Proposal for the 02 series of amendment to UN Regulation No. 73 (Lateral Protection Devices)

The text reproduced below was prepared by the experts from France. It proposes an amendment to UN Regulation No. 73 to improve the level of performance of lateral protection devices with regards to vulnerable road users' protection. The modifications to the current text of UN Regulation No. 73 are marked in bold for new characters and strikethrough for deleted characters.

Figure 1."

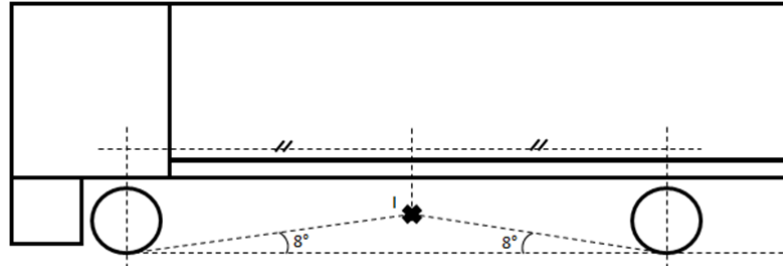
"12.8. The lower edge of LPD shall be defined as follow: ~~at no point be more than: 550 mm above the ground.~~

- If $I \leq 350\text{mm}$ then the ground clearance can be 350mm max.
- If $350\text{mm} < I \leq 450\text{mm}$ then the ground clearance is I
- If $450\text{mm} < I$ then the ground clearance is 450mm max.

With point I defined as mentioned in figure 1.

Figure 2."

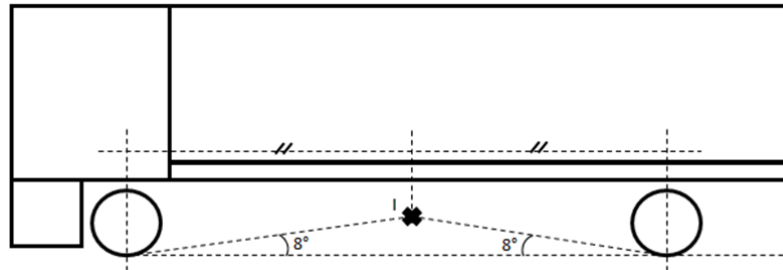
- "15.6. The lower edge of LPD shall be defined as follow: ~~at no point be more than 550 mm above the ground.~~
- If $I \leq 350$ mm then the ground clearance can be 350 mm maximum;
 - If $350 \text{ mm} < I \leq 450$ mm then the ground clearance is I;
 - If $450 \text{ mm} < I$ then the ground clearance is 450 mm maximum;
- with point I defined as mentioned in Figure 2.
